From: Scott Oestriecher <soestriecher@gvaengineering.com>
Sent: Friday, April 21, 2023 2:31 PM
To: Pete Priola <ppriola@mathesbrierre.com>; 'David Code' <dcode@gvaengineering.com>
Subject: RE: SBPL WiFi

Subject: Replies to Doug Landry's email from 4/23/2023 (re: Library lighting poles, conduit, and WiFi)

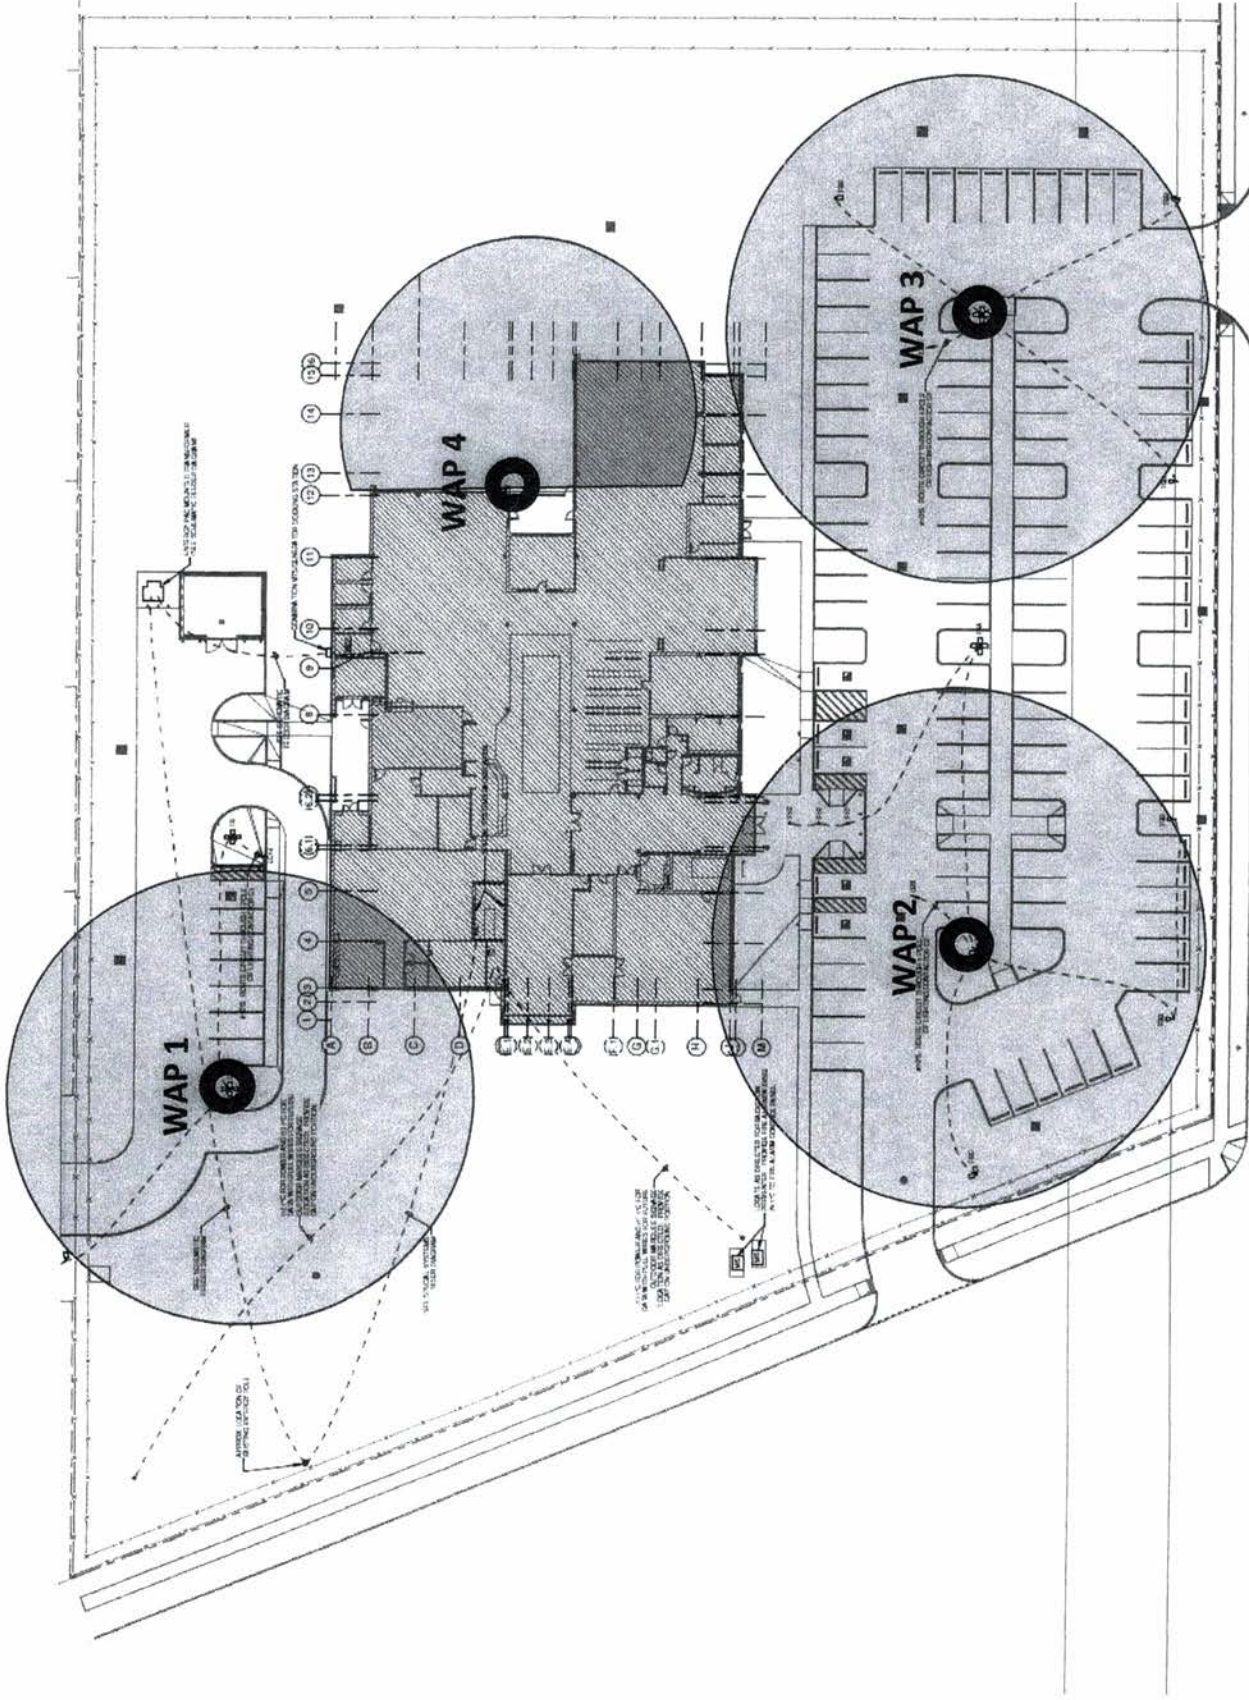
3. **Outdoor WAP locations.** The position of the WAPs are shown in the drawing attached, circled in black. Specifically, these are the northernmost and southernmost poles in the center of the lot, the southernmost post in the staff parking lot island, and the attached eave/roof overhang of the "smoking porch". This porch installation should have the wire enclosed inside a metal junction box, so that the WAP can be attached to the box..

As far as the additional request being made besides the outdoor WAP's, we are not considering those at this time. Dwight, yourself and Janet have done a great job providing me and the design team your end-user needs, comments and concerns about the design and we greatly appreciate that as I said in the meeting last week. But, we have to get this project bid and that needs to be everyone's focus at this time.

OUTDOOR ACCESS POINTS (WiFi)

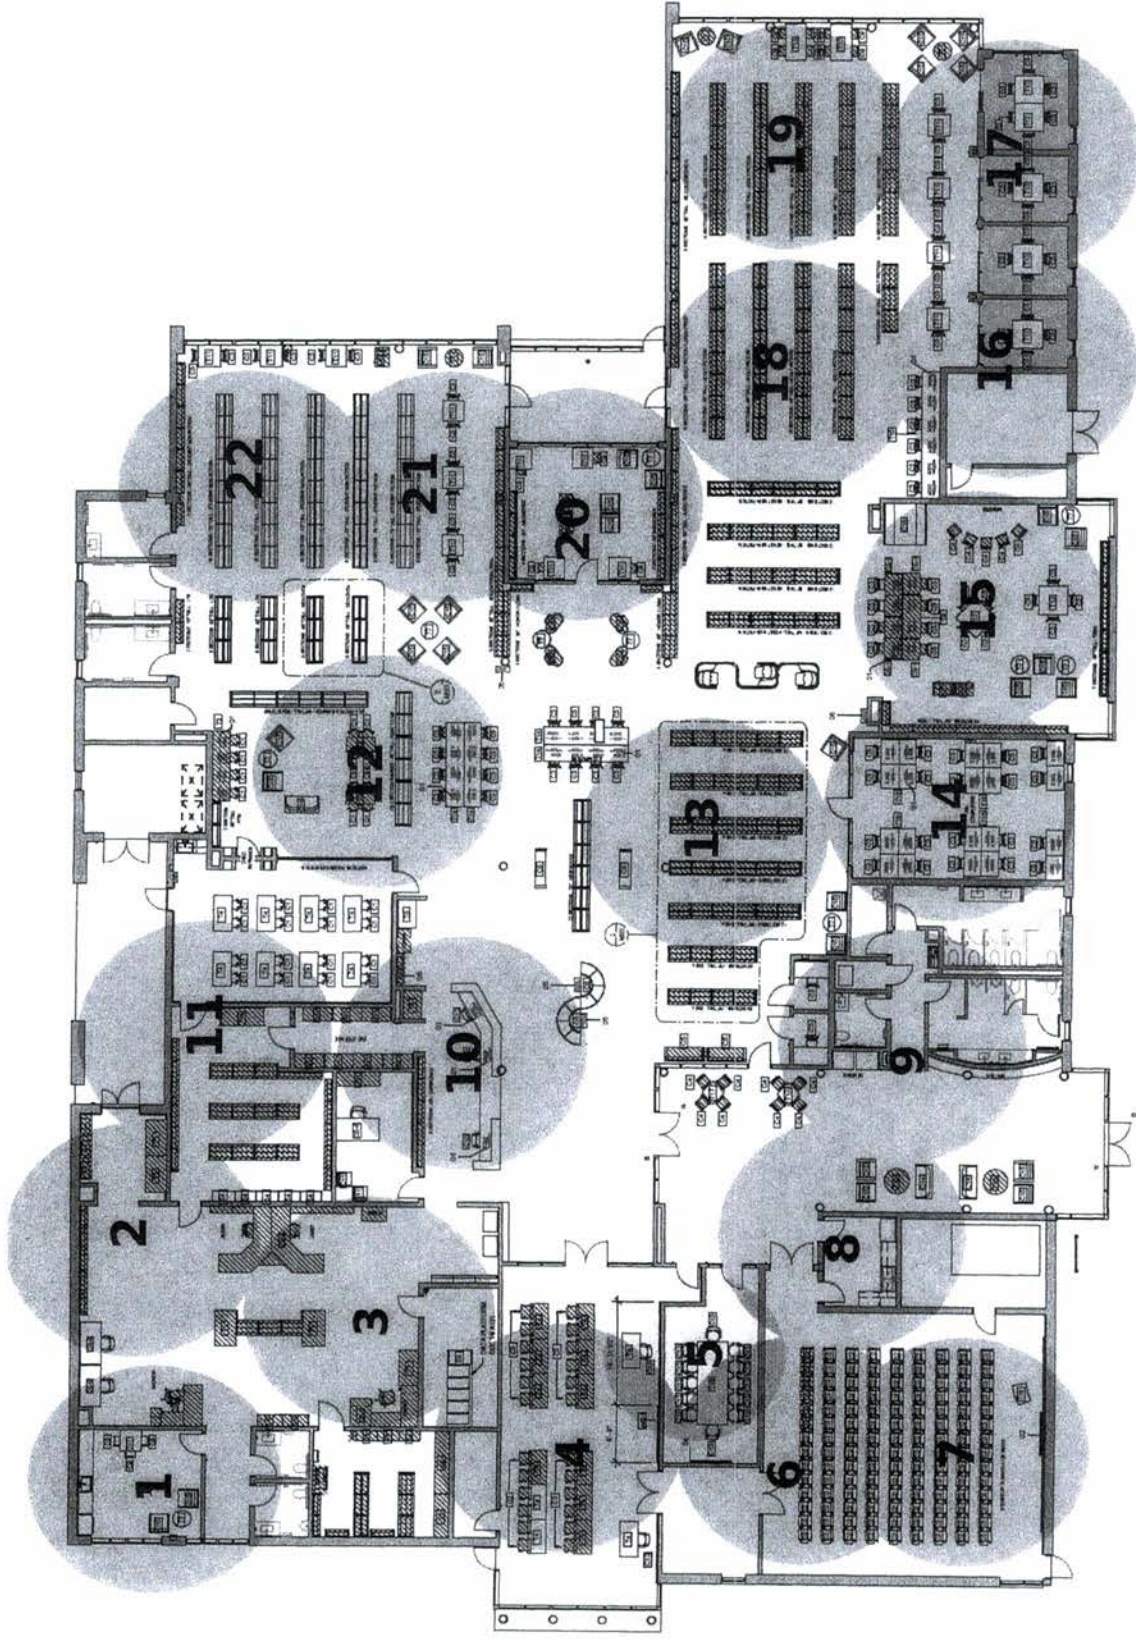
I have included a drawing (third page of attachment, circled in black) showing 6 lighting poles that should sufficiently cover the patron and staff parking lots. The cost of running these conduits and wires now would be far cheaper than to run them at a later date, which would require digging/trenching into the blacktop.
